VIRGINIA ELECTRIC AND POWER COMPANY  
RICHMOND, VIRGINIA 23261

REQUEST FOR ADDITIONAL INFORMATION  
REACTOR COOLANT SYSTEM VENTS (ITEM II.B.1)  
SURRY POWER STATION UNITS 1 AND 2

REQUEST FOR ADDITIONAL INFORMATION

SURRY 1 & 2

RCS VENT SYSTEM DISCHARGE POINTS

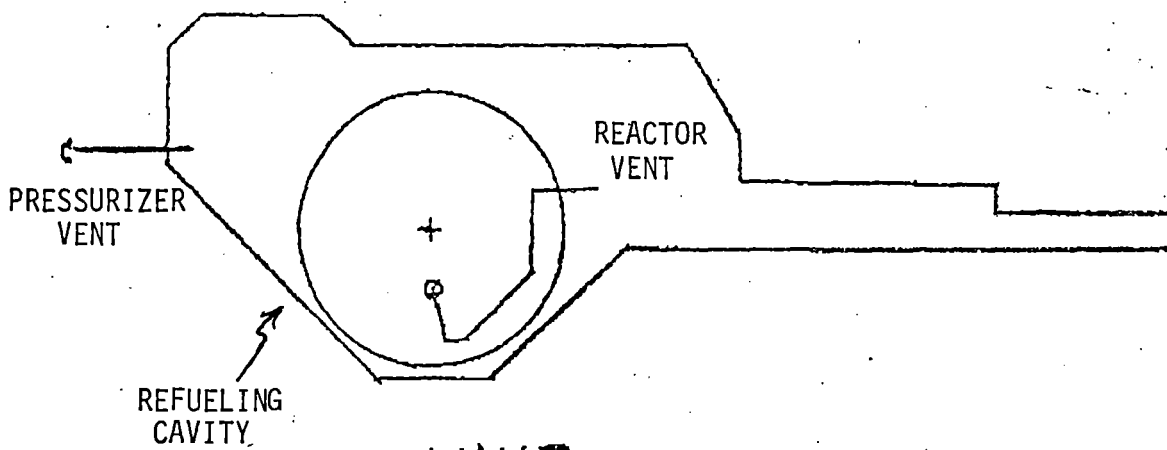
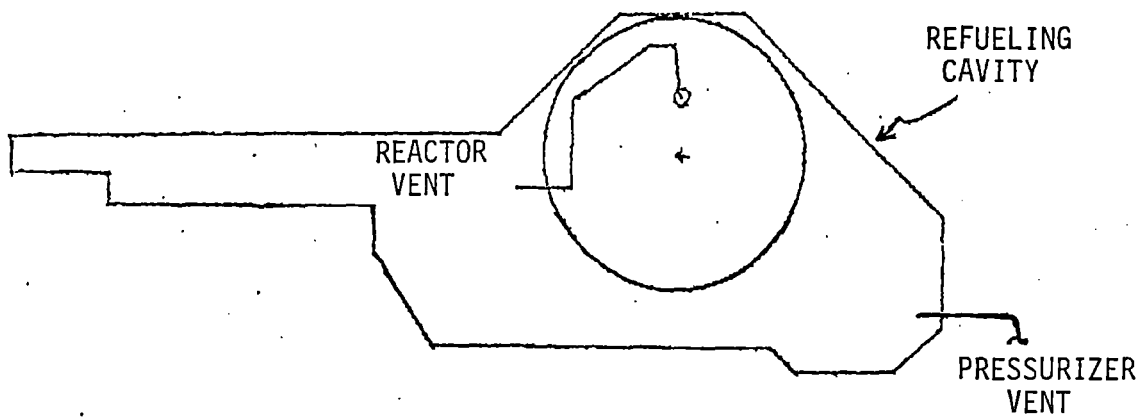
5. Verify that any nearby structures, systems, and components essential to safe shutdown of the reactor or mitigation of the consequences of a design basis accident are capable of withstanding the effects of the anticipated mixtures of steam, liquid, and noncondensable gas discharging from the reactor vessel head and pressurizer venting system.

Response: The spray from both the RCS and Pressurizer Vent Systems are directed into the refueling cavity such that they do not impinge on any components. The pressurizer vent system discharge is directed straight down into the refueling cavity. The RCS Vent System discharge is directed at a 45° angle into the refueling canal from the reactor vessel head. The attached sketch (Attachment III) details the approximate location of the vent system discharge for both units. All components in this area were originally designed or have been qualified to withstand the effect of a LOCA, therefore, no additional analysis need be performed.
